1 Products affected

3 Detailed description of change

FMBC NEO, FMAC ECO					0118.2077	
Creation date:	Created by:	Release date:	Released by:	Notification No.	Index	Page
16.09.2011 08:31:54	BLU	16.09.2011	BLU	22331	-	1 von 2

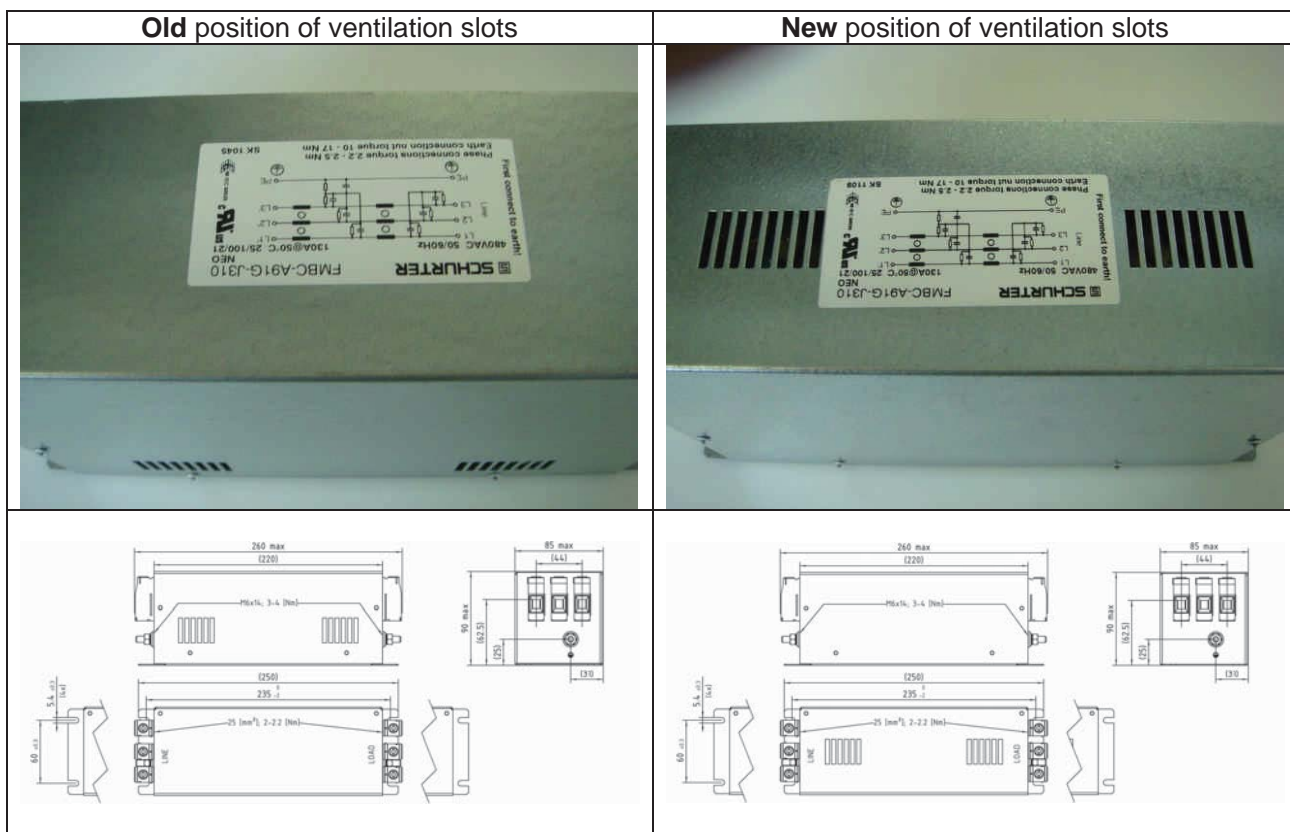
Ventilation slots shifted from filters lateral side to top side of housing.

Improved heat dispersion.
